**Nagan Family Objection to Council Development Application
Number MCUI 2024_5682/1
Sand Extraction Proposal on Lot 1 on RP893855, Bonnie Doon
Road, Killaloe, 4877**

Re: Council Application Number MCUI 2024_5682/1

Submissions made by [REDACTED] objecting to approval of Impact Assessable Development Application (DA) in Town Planning Report prepared by and lodged by RPS AAP Consulting Pty. Ltd. (rps) on behalf of N Q Asphalt Pty Ltd., (Applicant) in respect to Lot 1 on RP 893855 for a Material Change of Use from Rural Zoning to Extractive Industry Use lodged on 16 October 2024 (properly made on 30 October 2024).

Plate 1 Test Pitting on Site Showing Clean Sand Resource

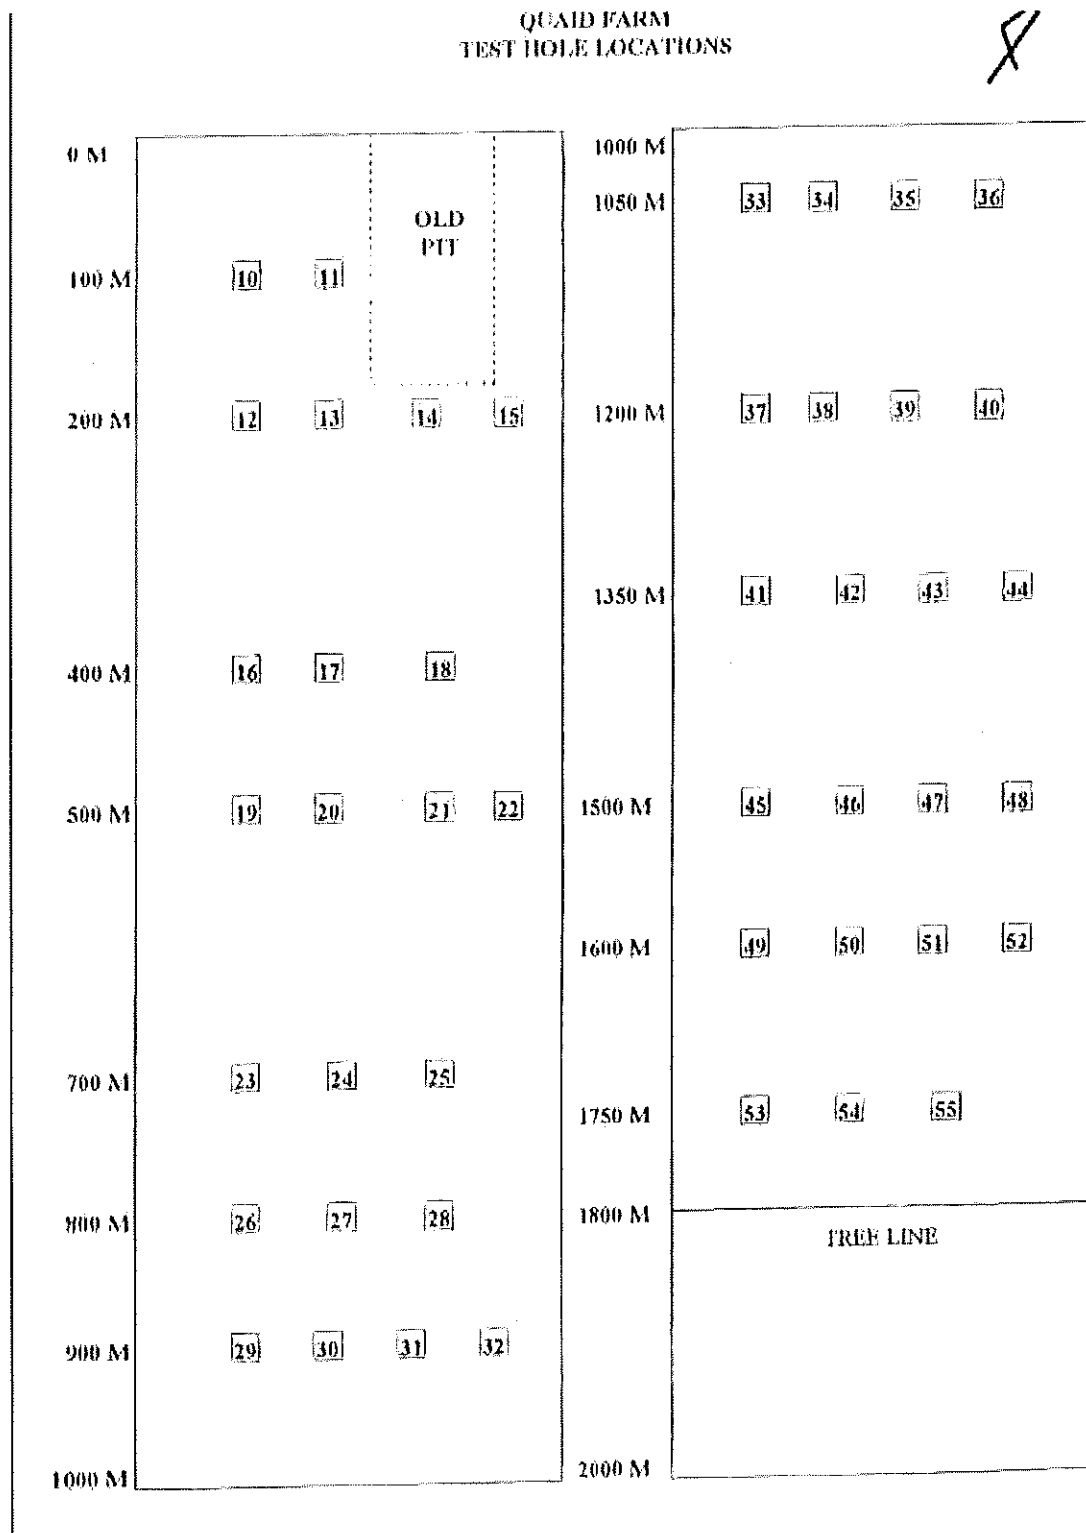
Above: inadequate testing for Acid Sulfate Soil or PASS Material from the applicant. One test pit dug over a 22 hectare site does not constitute a thorough and comprehensive analysis. Also, note no coordinates were given for the 1 test pit dug. rps letter to council dated 26 November 2024.

TEST HOLE LOGS

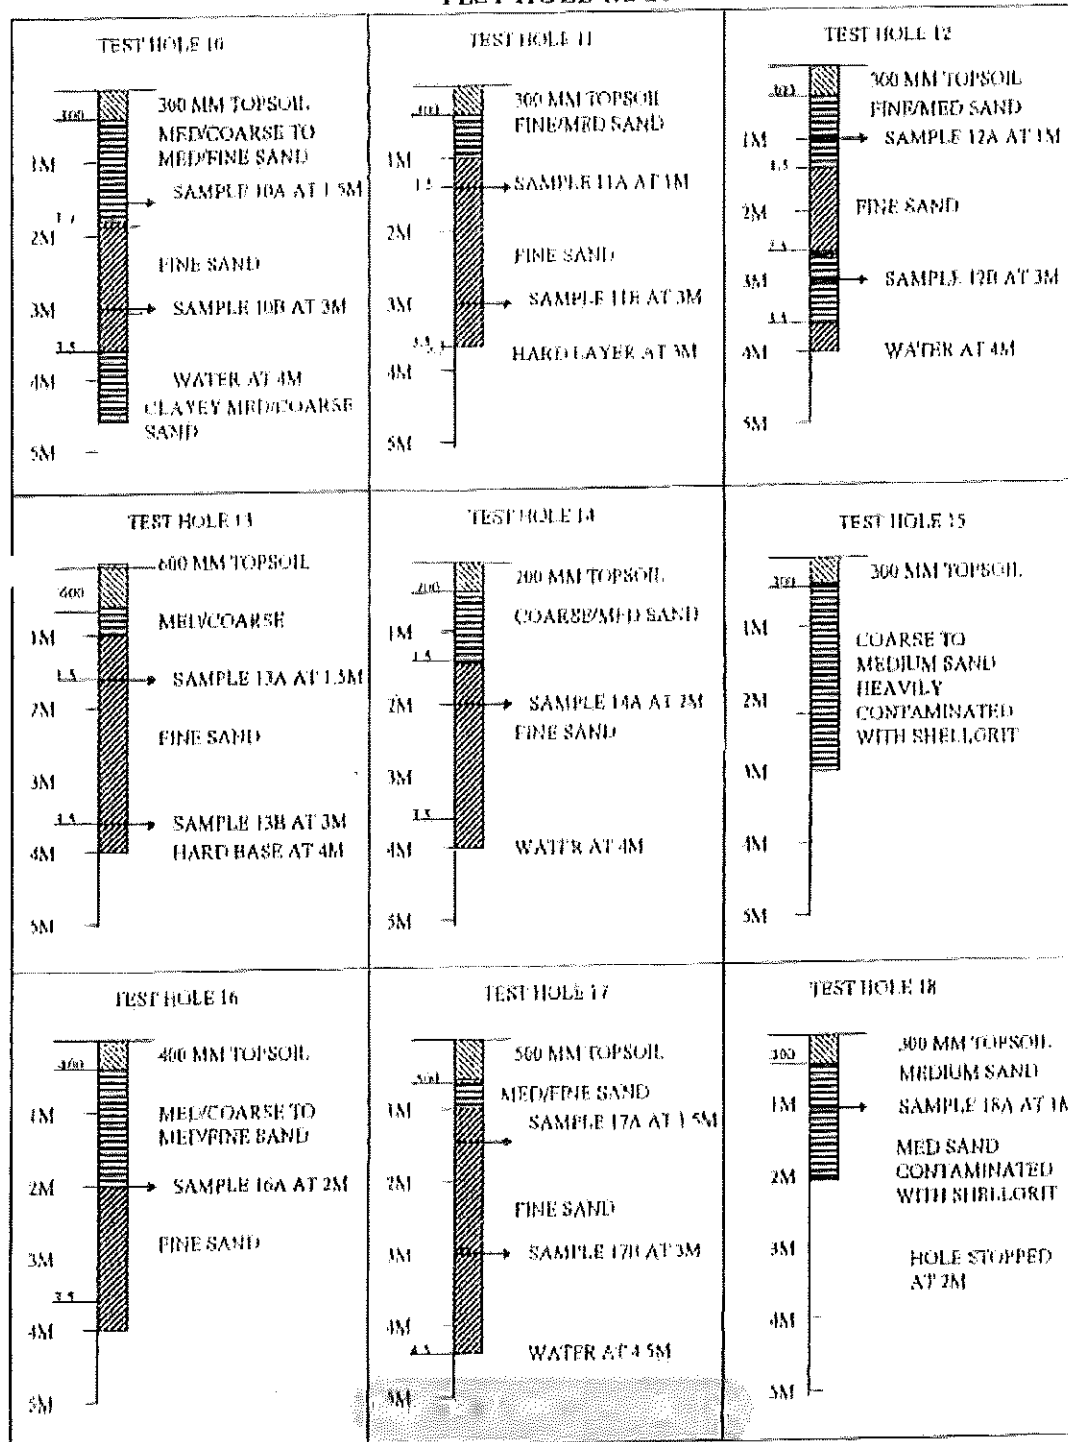
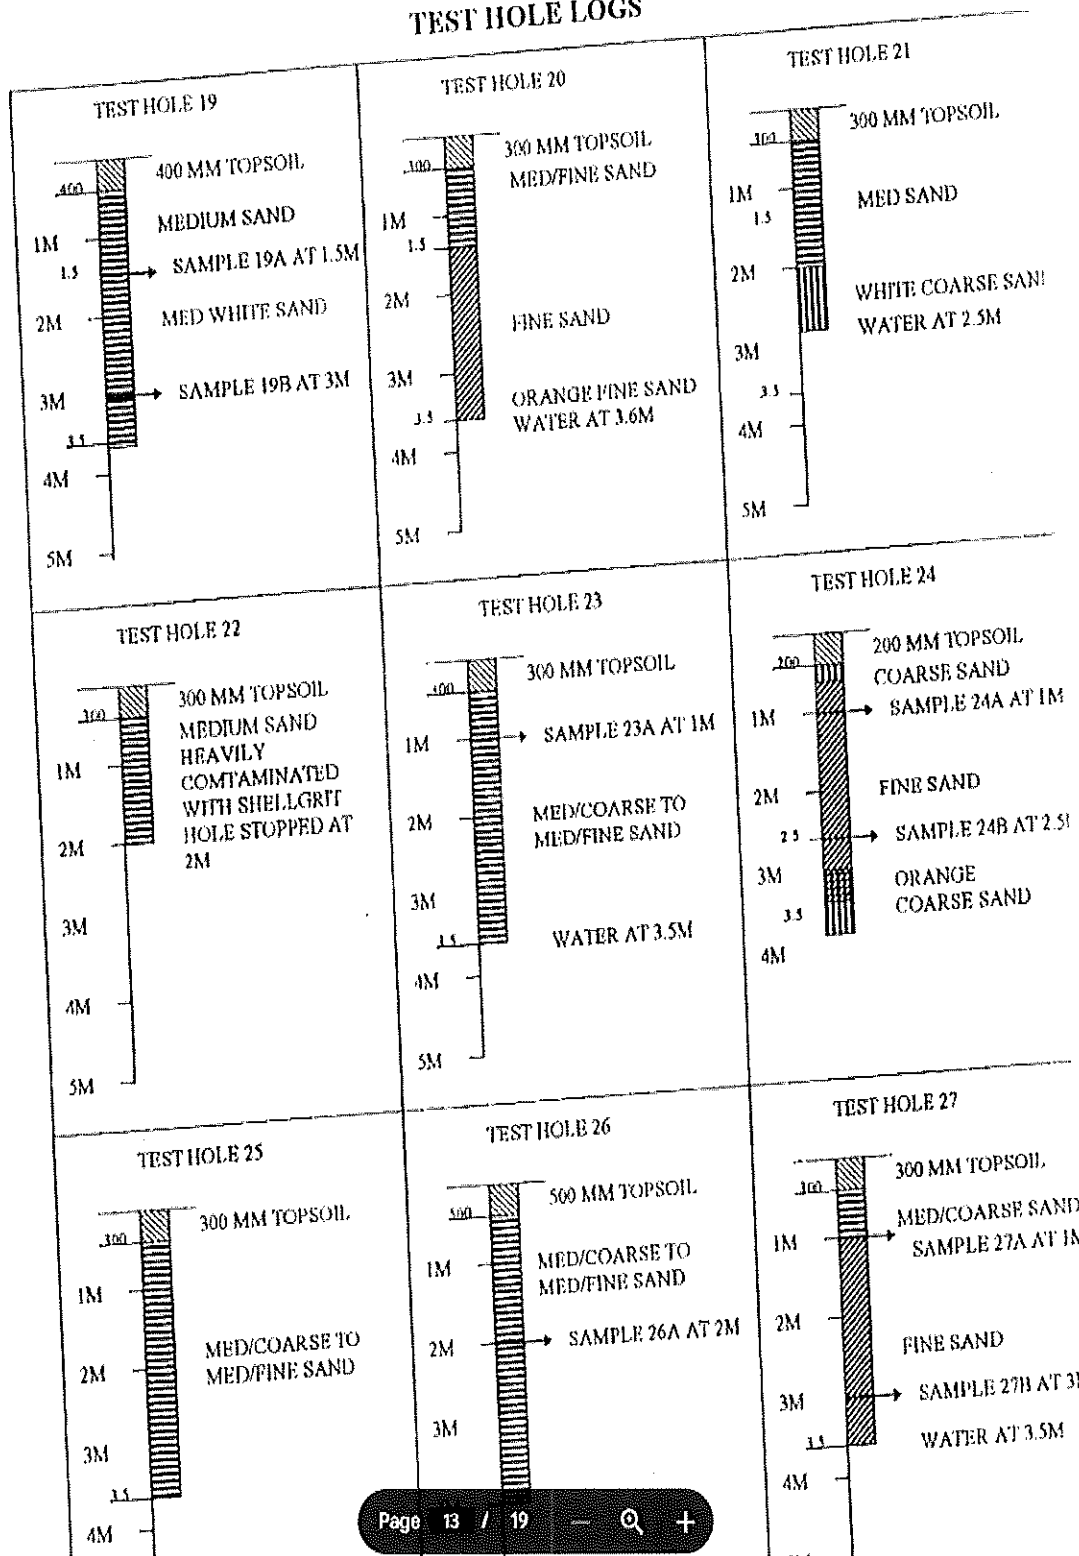
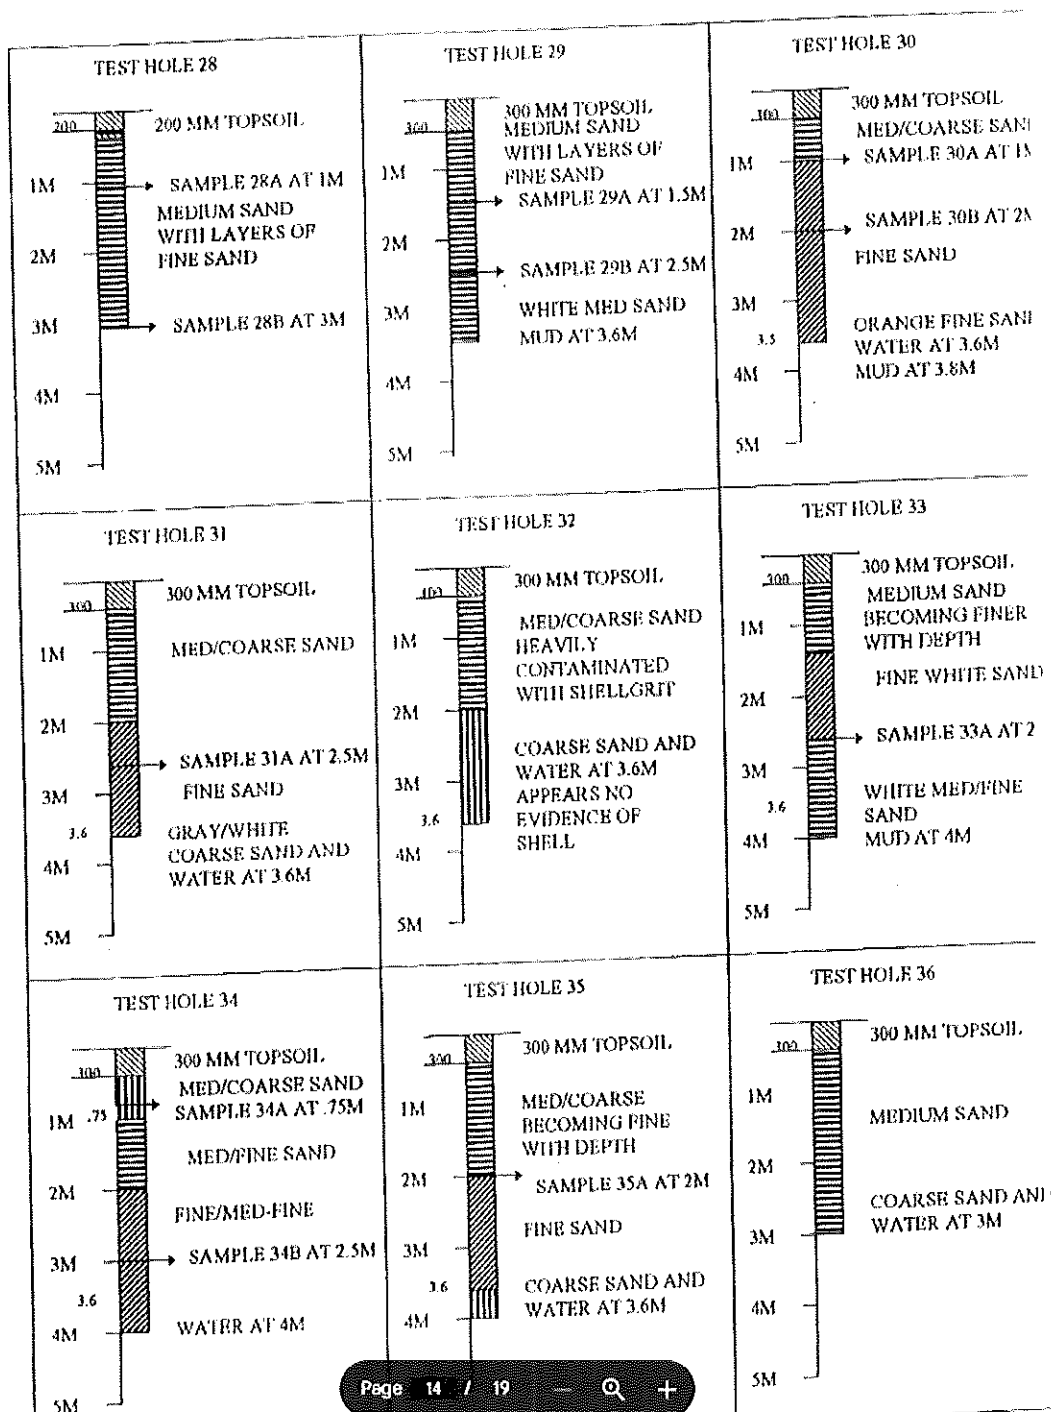
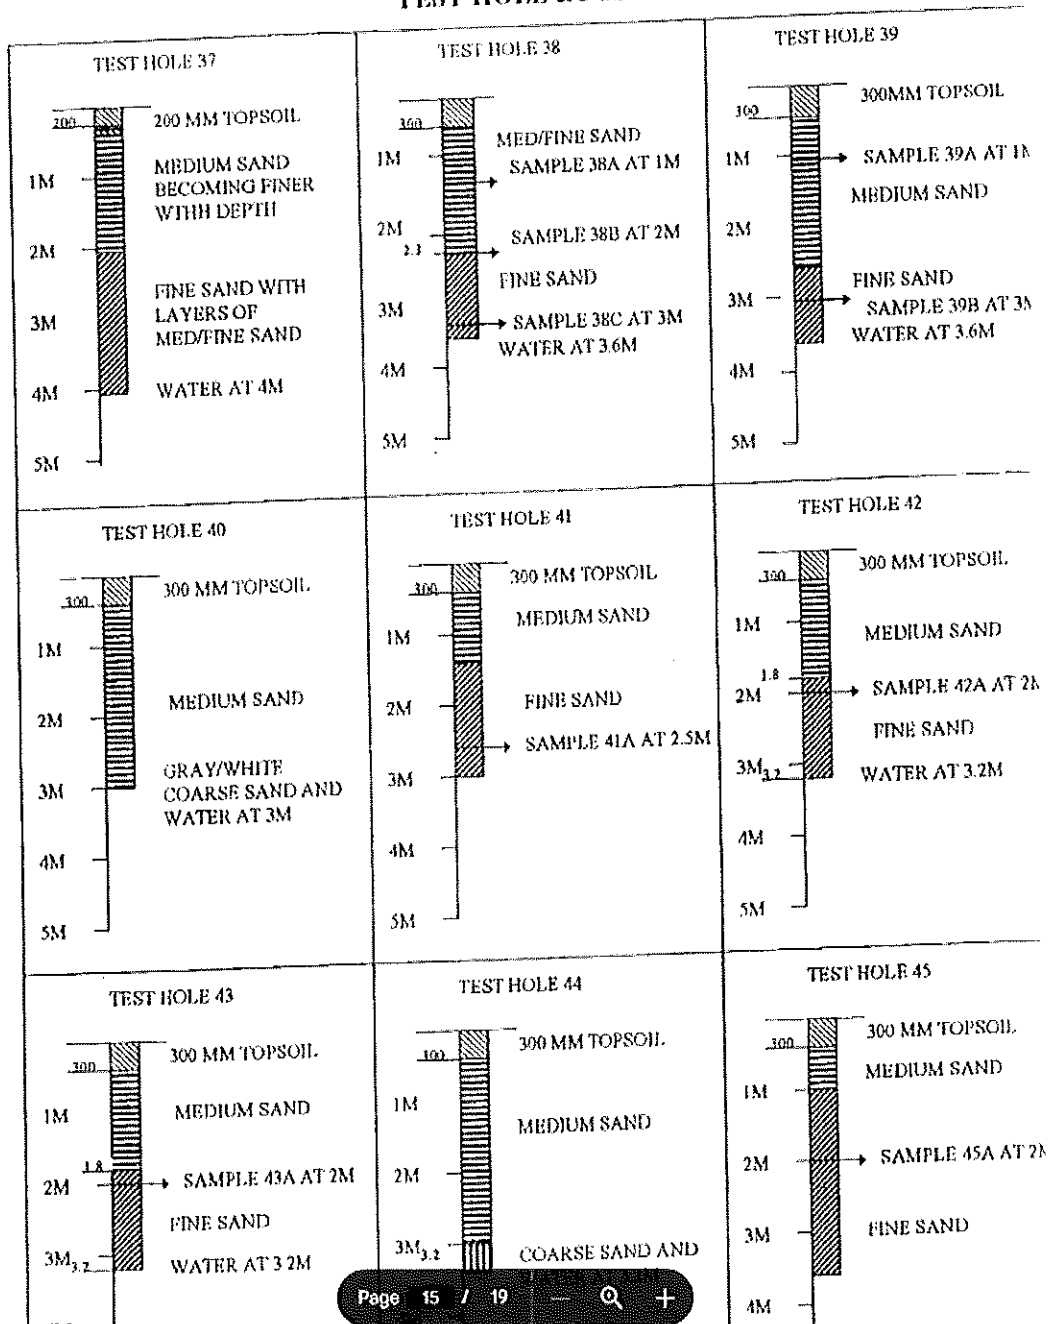
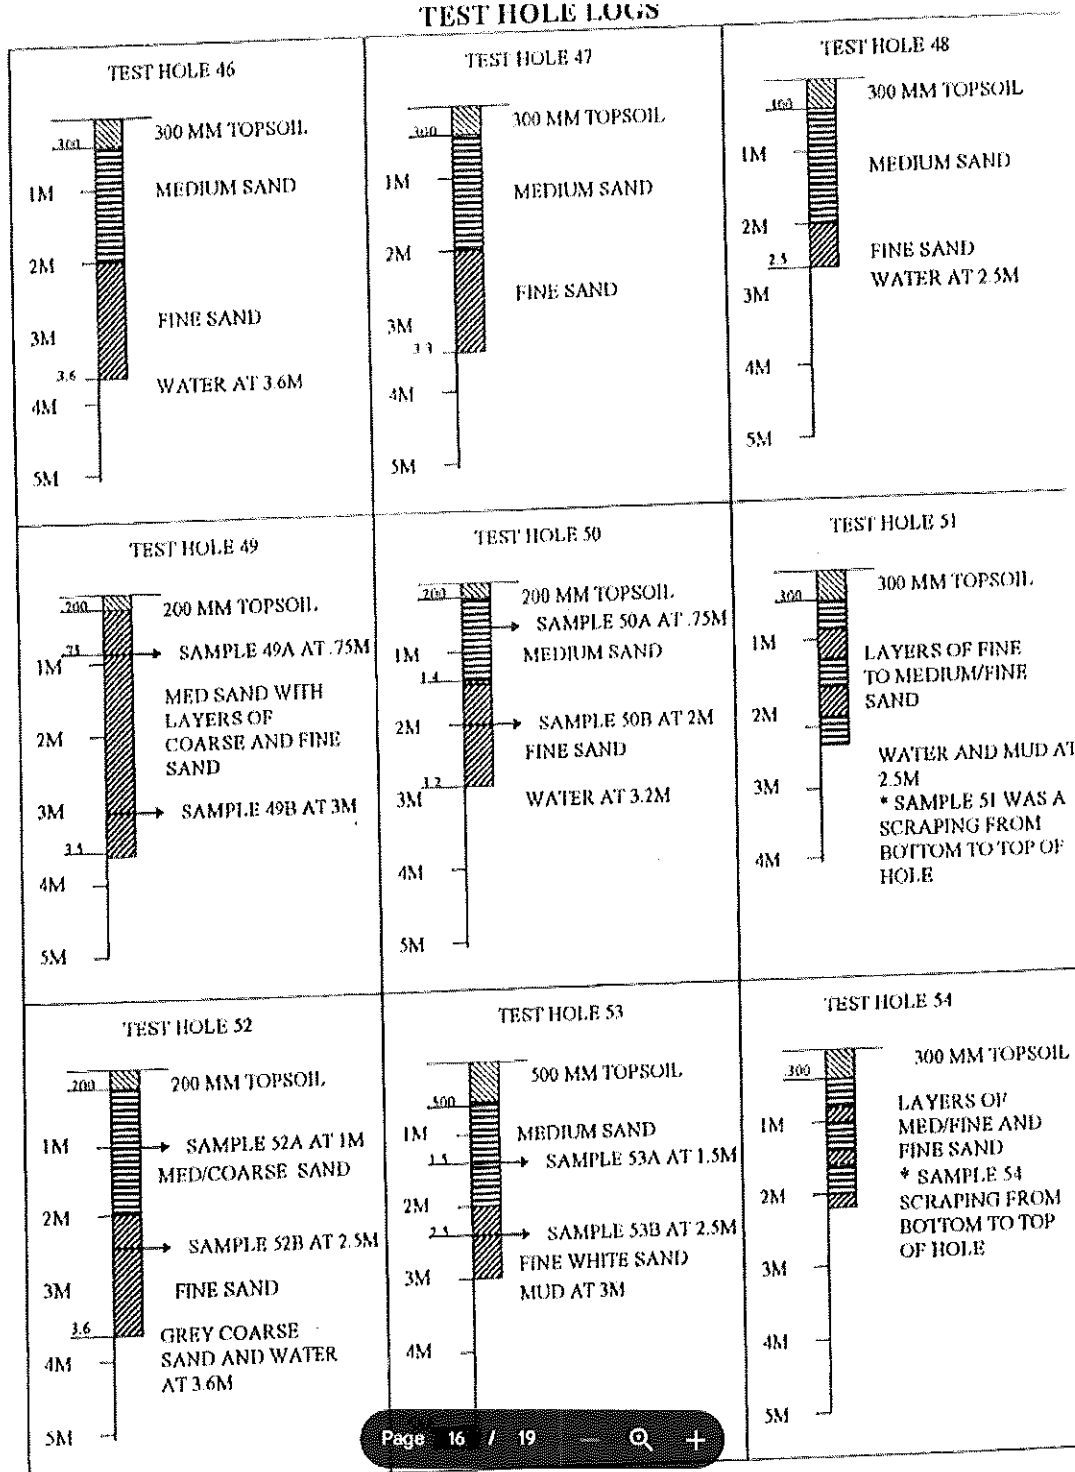
Below: Pioneer Concrete Soil Logs from 1994 (30 years old), do not include any testing for PASS material. rps letter to council 26 November 2024.

Figure 3: Extract of Site Plan

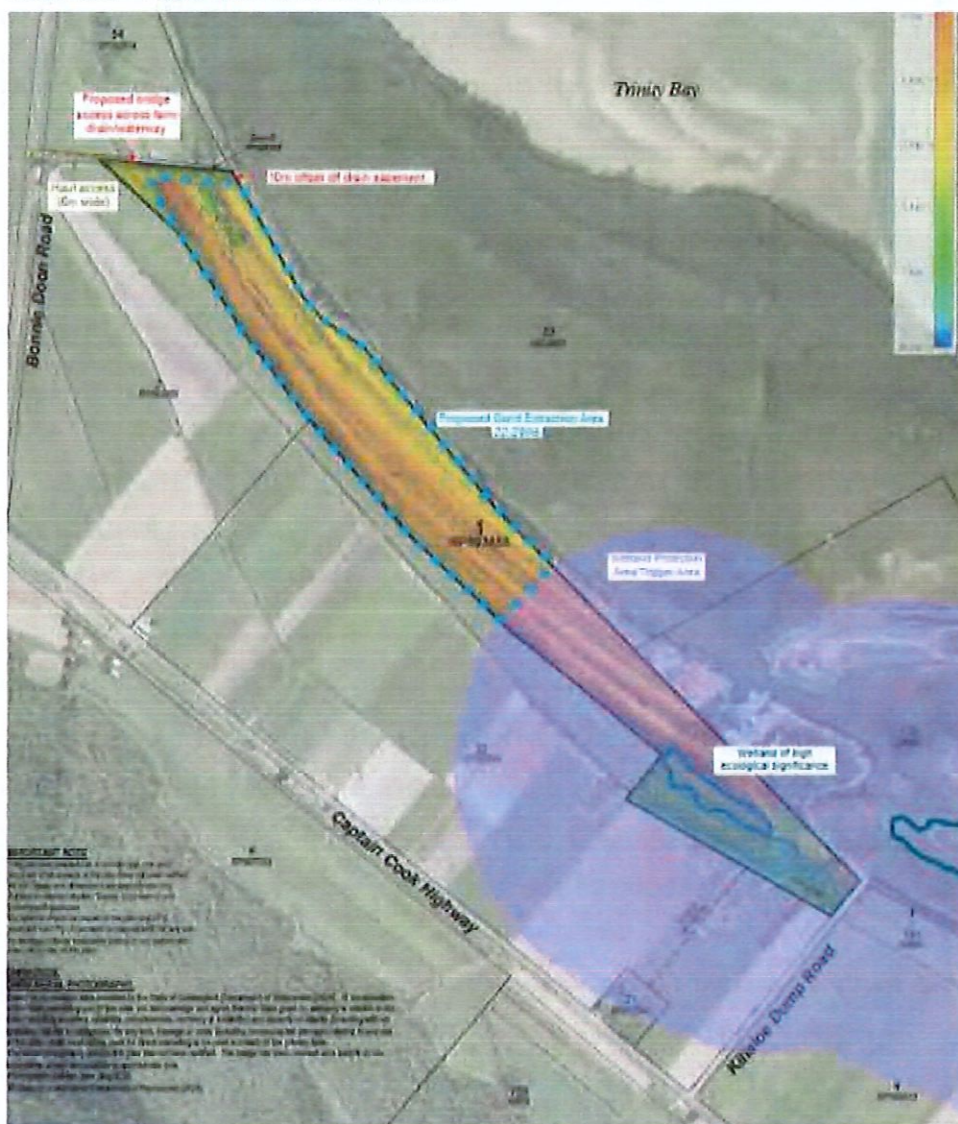
Our submission: rps town planning report's approach to mitigating impacts on matters of environmental significance is insufficient. The Natural Areas Overlay mandates avoiding impacts on wetlands, waterways, and high ecological value areas. Buffering and preservation of wetlands and waterways are critical for alignment with this overlay. (8.2.7 Natural-areas-Overlay)
